RESPONSE TO THE CONSULTANT'S DESIGN REVIEW COMMENTS						DATE		23.03, 2025				
PROJECT NAME: The Project of the New Port of Caio in Cabinda												
MAIN SUBJECT: RESPONSE TO CONSULTANT'S DESIGN REVIEW COMMENTS RAD-CRBC-134 DD PERSONAL GATE FREEZONE_SE20250314 (ARCH PART)						SECTION OF PROJECT		LOT 1 LOT 2 LOT 3 OTHER <input checked="" type="checkbox"/> <input type="checkbox"/> <input type="checkbox"/> <input type="checkbox"/>				
ROAD NETWORK	CIVIL	FIRE PROTECTION	ELECTRICAL	INSTRUMENT	STRUCTURAL	MECHANICAL PROCESS	HVAC	PLUMBING	GEOTECHNICAL	ESTIMATING	PROJECT	OTHER
<input type="checkbox"/>	<input type="checkbox"/>	<input type="checkbox"/>	<input checked="" type="checkbox"/>	<input type="checkbox"/>	<input checked="" type="checkbox"/>	<input type="checkbox"/>	<input checked="" type="checkbox"/>	<input checked="" type="checkbox"/>	<input type="checkbox"/>	<input type="checkbox"/>	<input type="checkbox"/>	<input type="checkbox"/>

PREPARED BY: DESIGN TEAM OF CRBC CAIOPORT PROJECT MANAGEMENT						REVIEW DOCUMENT REF. & DATE OF THE CONSULTANT		RAD-CRBC-134 DD PERSONAL GATE FREEZONE_SE20250314 (ARCH PART)				
REVIEWER BY: Gao Changsheng / CHIEF ENGINEER OF CRBC CAIOPORT PROJECT MA

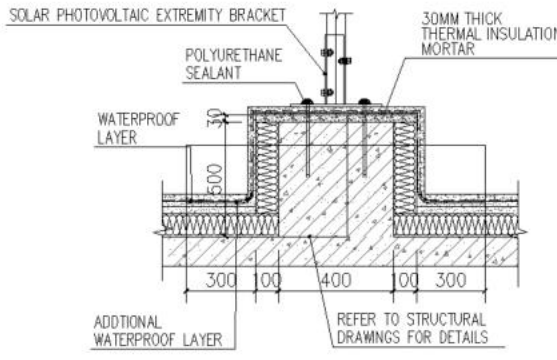
<p>Response: Accepted. It has been revised.</p>					
	<div>LOT1_DD_1022-A-03</div>	<p>add supplementary relevant sections</p> <p>Response: Accepted. It has been added.</p> <p>add threshold details</p> <p>Response: Accepted. It has been added.</p> <table><tr><th>DETAILS FOR ENTRANCE THRESHOLD</th><th>DETAILS FOR TOILET THRESHOLD</th></tr><tr><td><p>12MM THICK CERAMIC ANTI-SLIP TILE, 1:1 CEMENT PASTE POINTING 20MM THICK 1:3 CEMENT MORTAR 150MM THICK C35/45 REINFORCED CONCRETE (R10-200) 100MM THICK C12/15 CONCRETE PLAIN SOIL COMPACTION</p><p>INSIDE ±0.000 pv1 200 100 DOORSTONE OUTSIDE -0.020</p><p>0.4MM THICK POLYETHYLENE FILM</p><p>MU5 CONCRETE HOLLOW BRICK (CONCRETE FILLING C20/25)</p><p>EXPANDED POLYSTYRENE GASKET</p><p>12 1:10</p></td><td><p>GUARD'S ROOM ±0.000 pv1 200 DOORSTONE TOILET -0.020 pv2</p><p>0.4MM THICK POLYETHYLENE FILM</p><p>MU5 CONCRETE HOLLOW BRICK (CONCRETE FILLING C20/25)</p><p>EXPANDED POLYSTYRENE GASKET</p><p>13 1:10</p></td></tr></table> <p>- recheck the slopes as it can't work together for having the designed ramps</p> <p>- check the ramp requirements for disability access</p> <p>Response: Accepted. It has been revised. Modify the elevation of the entrance. The slope of the ramp should be 6%, meeting the requirements for disability access.</p>	DETAILS FOR ENTRANCE THRESHOLD	DETAILS FOR TOILET THRESHOLD	<p>12MM THICK CERAMIC ANTI-SLIP TILE, 1:1 CEMENT PASTE POINTING 20MM THICK 1:3 CEMENT MORTAR 150MM THICK C35/45 REINFORCED CONCRETE (R10-200) 100MM THICK C12/15 CONCRETE PLAIN SOIL COMPACTION</p> <p>INSIDE ±0.000 pv1 200 100 DOORSTONE OUTSIDE -0.020</p> <p>0.4MM THICK POLYETHYLENE FILM</p> <p>MU5 CONCRETE HOLLOW BRICK (CONCRETE FILLING C20/25)</p> <p>EXPANDED POLYSTYRENE GASKET</p> <p>12 1:10</p>	<p>GUARD'S ROOM ±0.000 pv1 200 DOORSTONE TOILET -0.020 pv2</p> <p>0.4MM THICK POLYETHYLENE FILM</p> <p>MU5 CONCRETE HOLLOW BRICK (CONCRETE FILLING C20/25)</p> <p>EXPANDED POLYSTYRENE GASKET</p> <p>13 1:10</p>	A
DETAILS FOR ENTRANCE THRESHOLD	DETAILS FOR TOILET THRESHOLD						
<p>12MM THICK CERAMIC ANTI-SLIP TILE, 1:1 CEMENT PASTE POINTING 20MM THICK 1:3 CEMENT MORTAR 150MM THICK C35/45 REINFORCED CONCRETE (R10-200) 100MM THICK C12/15 CONCRETE PLAIN SOIL COMPACTION</p> <p>INSIDE ±0.000 pv1 200 100 DOORSTONE OUTSIDE -0.020</p> <p>0.4MM THICK POLYETHYLENE FILM</p> <p>MU5 CONCRETE HOLLOW BRICK (CONCRETE FILLING C20/25)</p> <p>EXPANDED POLYSTYRENE GASKET</p> <p>12 1:10</p>	<p>GUARD'S ROOM ±0.000 pv1 200 DOORSTONE TOILET -0.020 pv2</p> <p>0.4MM THICK POLYETHYLENE FILM</p> <p>MU5 CONCRETE HOLLOW BRICK (CONCRETE FILLING C20/25)</p> <p>EXPANDED POLYSTYRENE GASKET</p> <p>13 1:10</p>						
	<div>LOT1_DD_1022-A-04</div>	<p>1. - no dimensions and elevations for setting up the screeding</p> <p>Response: Accepted. Dimensions and elevations have been added.</p> <p>2. - details for penetrations missing; penetrations has to be confirmed on the structural design</p> <p>Response: Accepted. Details have been added.</p> <p>- details of equipment supports missing</p> <p>Response: Accepted. Details have been added.</p> <p>3. -no dimensions and elevations for setting up the screeding</p> <p>Response: Accepted. Dimensions and elevations have been added.</p> <p>4. detail for photovoltaic system supports are missing</p> <p>Response: Accepted. Details have been added.</p>	A

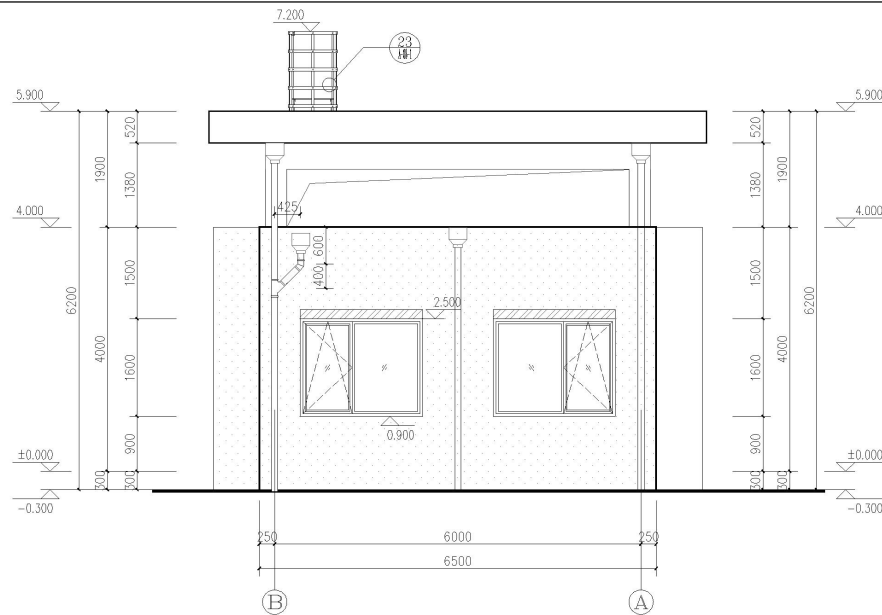
2. - add proper detail and coordinate with plumbing design - refer to LOT1_DD_1021-P-04 and LOT1_DD_1021-P-05

Response: Accepted. It has been coordinate with plumbing design and has been revised.

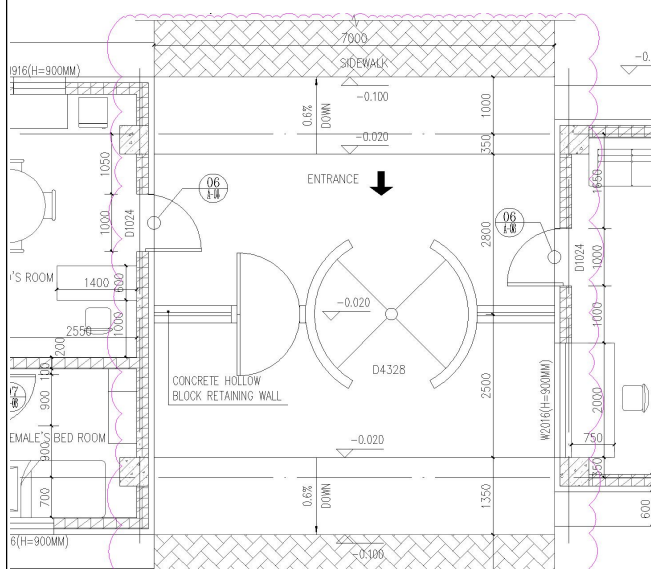
3. roof is exposed on 3 sides - not acceptable for the rain water from the roof to dripdown on the facade unto walkway - add parapet and collect it through the rainwater system; adjust the slopes accordingly

Response: Accepted. It has been revised, add parapets and downspouts to implement organized drainage.

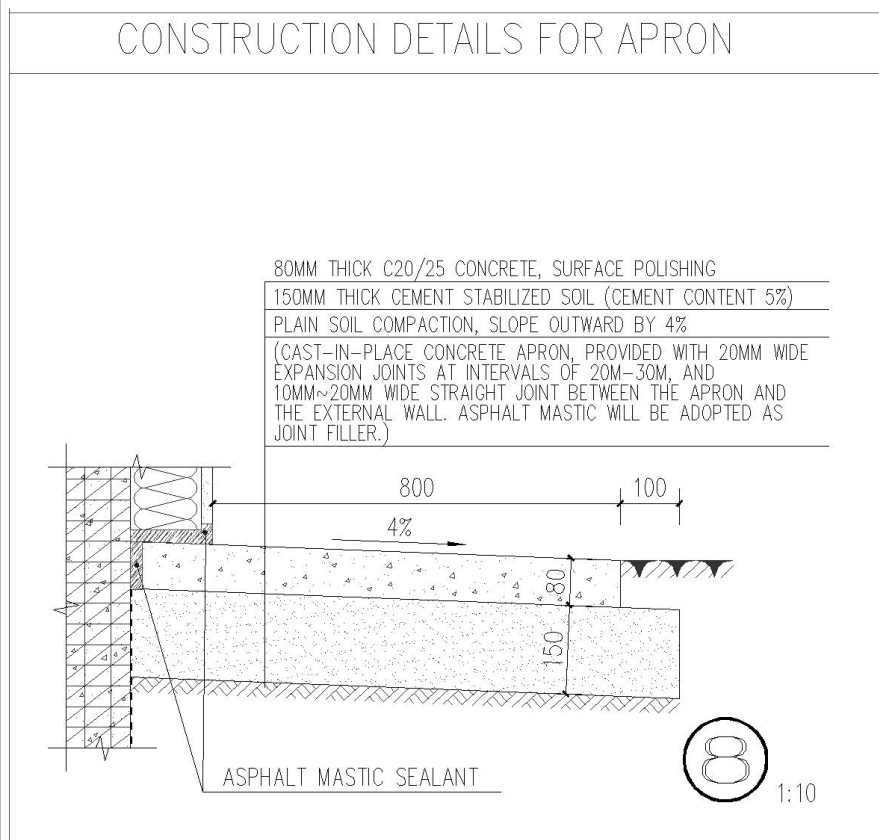
6. missing details of the turnstile

Response: Accepted. Add the turnstils details LOT1_DD_1022-A-09.
